MW13/14/16 Difficult Airway Management Simulator Series

Parts change announcement

2019.06

The pin attached to the lower jaw

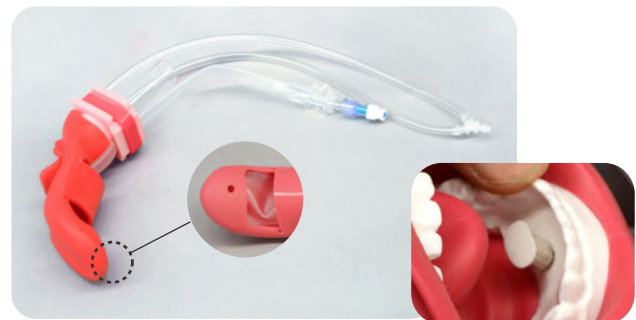
Previously, the anchor pin to connect the tip of tongue and the lower jaw was attached to the tongue side (11392-030). Now the design of the parts has changed so that the pin is fixed to the jaw side (11392-080). This improvement permits longer life of the tongue.

Previous model user needs the pin that is fixed to the jaw. Accordingly, one (1) pin is included in this parts set.

Existing part: 11392-030

New part: 11392-080

- **Instruction on tongue parts replacement (11392-080)**

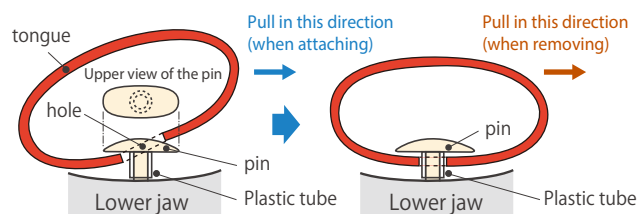
The method to assemble and disassemble the new tongue part will differ from those found on the instruction manual. Please see the following instructions on how to attach and remove the tongue part from the lower jaw.

Hook one side of the pin's head through the hole at the tip of the tongue. Then pull the tongue in the opposite direction to expand the hole. Once the hole is large enough, fit the pin through the hole to secure the tongue in place. To remove, pull the tongue to one side to expand the hole and remove from the pin.
